REVISE WAREHOUSE RACKING AS PER RA-37.0

BIRD
Project: 00097
MERIT FUNCTIONAL FOODS
The receipt and review of this submission is for the sole purpose of reviewing general conformance with the construction and / or design concepts only. The review of this submission does not relieve the supplier or subcontractor of the complete responsibility for errors or omissions or for non-compliance with the contract documents. The Contractor is responsible for all dimensions and the requirements of the contract documents as they relate to this submission.
REVIEWED
REVIEWED AS NOTED
REVISE AND RESUBMIT
REJECTED AS INCOMPLETE
REVIEWED BY: Allan Schreiner
BIRD CONSTRUCTION

Title: Layout & Elevations

Dwg. No : DGJ20200114QDG6232 REV 5 Sheet: 1 of 1

BASEPLATE REACTIONS

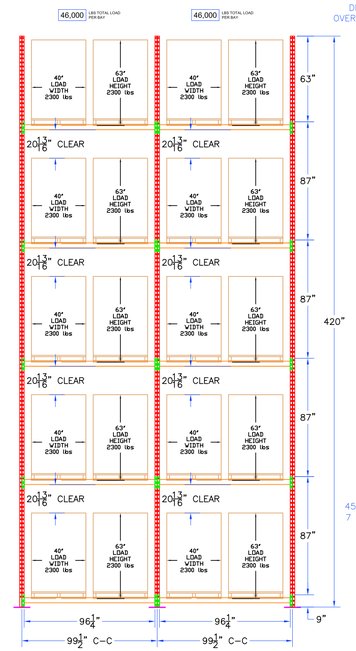
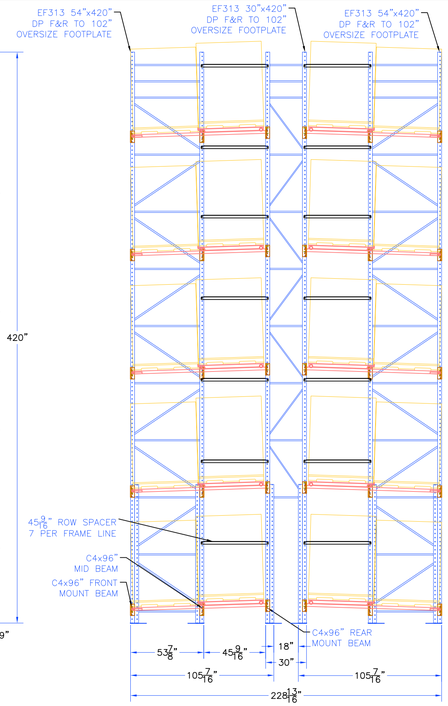
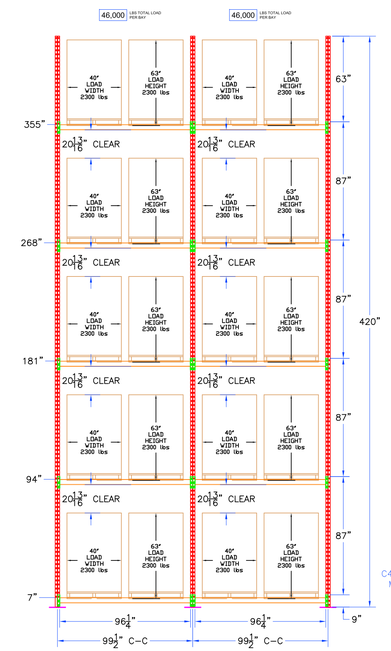
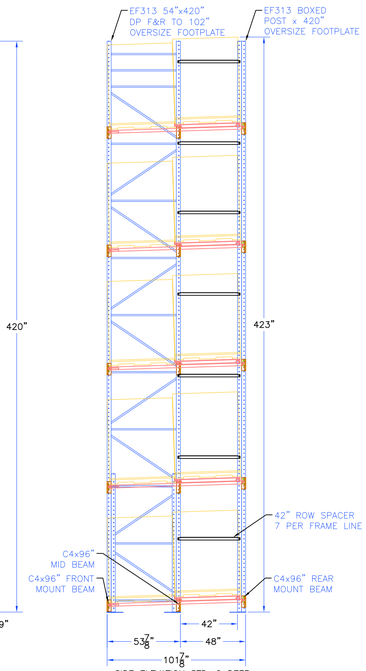
1.25DL+1.5LL revise loads

not acceptable
max factored post load 24 kips
